UNITED STATES
NUCLEAR REGULATORY COMMISSION
WASHINGTON, D. C. 20555

SAFETY EVALUATION BY THE OFFICE OF NUCLEAR REACTOR REGULATION
OF RECOMMENDED MODIFICATION TO THE
R.G. 1.76 TORNADO DESIGN BASIS FOR THE ALWR

FIGURE 1 Wind Speeds (mph) with a 10^{-7} Probability of Occurrence Estimated from the Upper End of the 90% Strike Probability Confidence Interval (Fig. 30 from NUREG/CR4461)

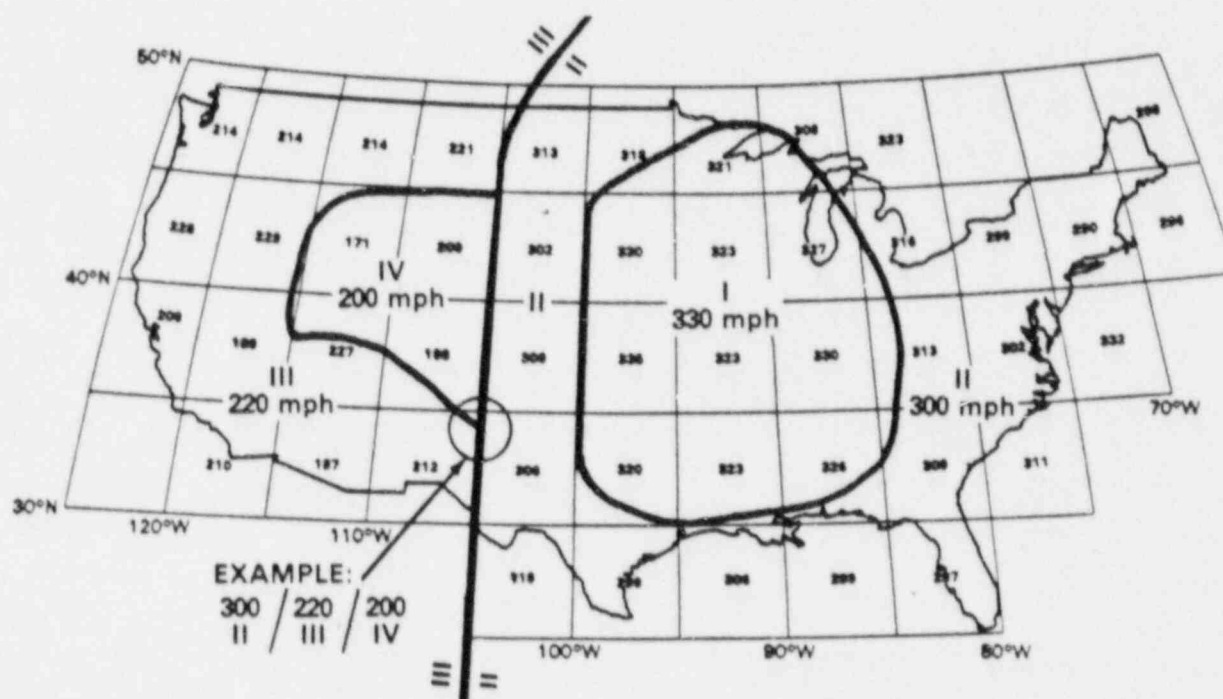
The staff has reviewed the contractor's study and found agreement with the proposed revisions to the WASH-1300 methodology but believes that, in order to take into account uncertainties in the data base and analyses, the upper 90% strike probability confidence level should be utilized for estimating the probability of tornado occurrence. In keeping with the R.G. 1.76 regulatory position which allows for lessening of the DBT based upon a comprehensive analysis to justify less conservative DBT parameters, the staff concluded that the 10^{-7} /yr probability of occurrence at the upper 90% confidence level from the contractor report may be utilized as the DBT. Fig. 1, which is identical to Figure 30 in NUREG/CR-4461, shows the associated wind speed by 5-degree latitude/longitude sectors throughout the United States. These sectors may be assigned to four regions (see Figure 2), which can be characterized by the following DBT parameters:

Based on its review described above, the staff concludes that the tornado design criteria in Table II and Figure 2 are acceptable on an interim basis for ALWRs until such time as R.G. 1.76 is revised.
